Your Ref
WA/26/17/HH
Our Ref
PLAN-018163
Date
25/05/2017

Proposal: Single storey rear extension, conversion of garage to habitable space & replacement of existing clay roof tiles with slate.

Site: Park View, Avisford Park Road, Walberton BN18 0AP.

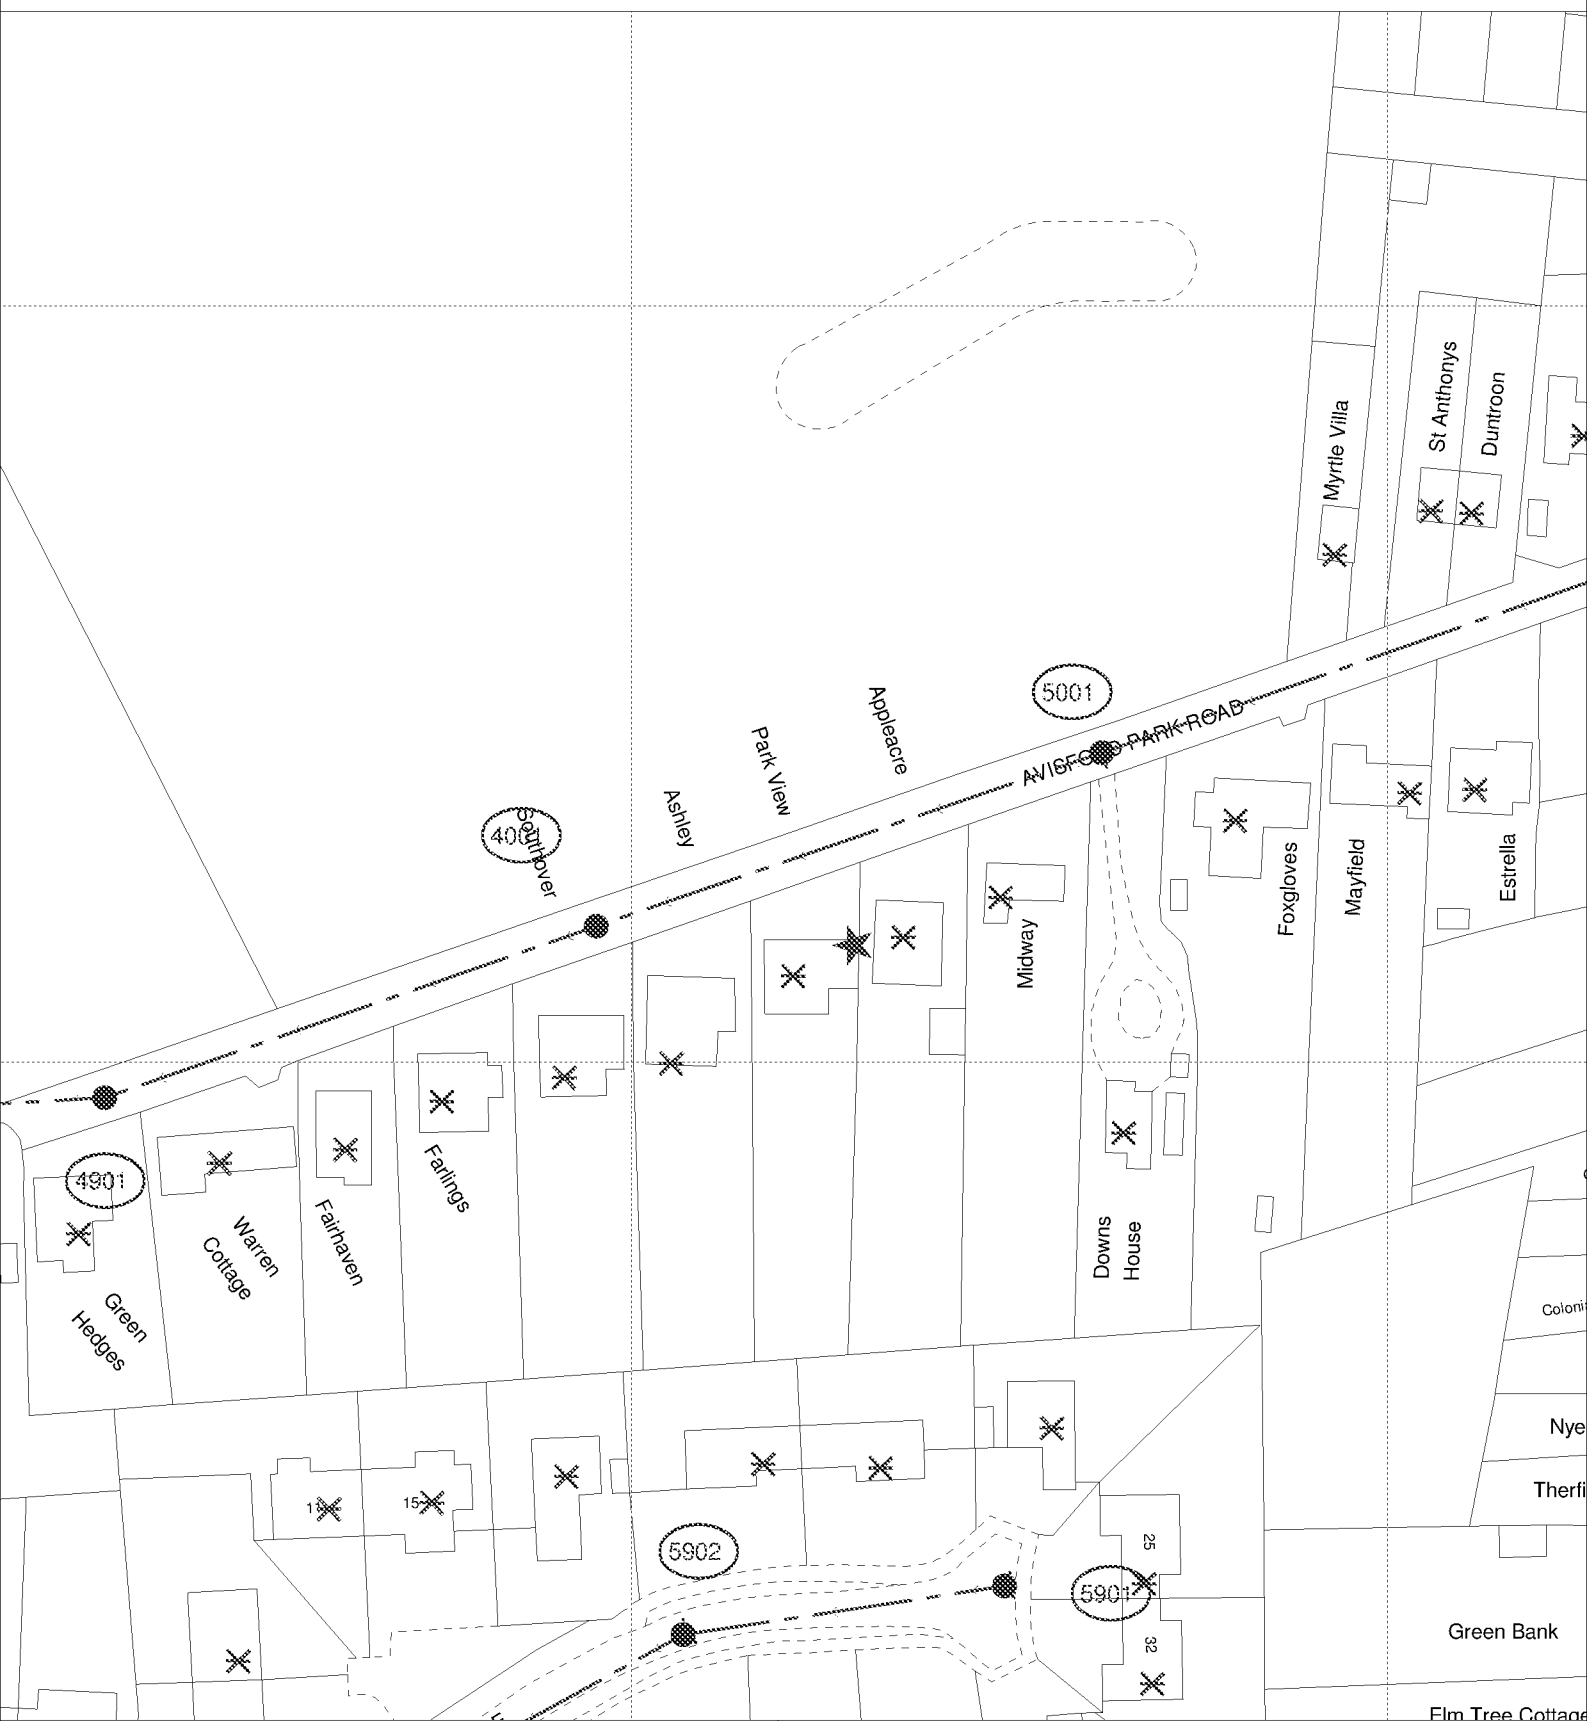
Due to surface water inundation issues in the Lidsey Catchment "The applicant is advised to adopt, where appropriate, the measures in the table "Practical measures to reduce the potential impacts of development".

Developer should look to protect the public sewerage system from inundation and infiltration, which contribute to flooding in unfavourable conditions.
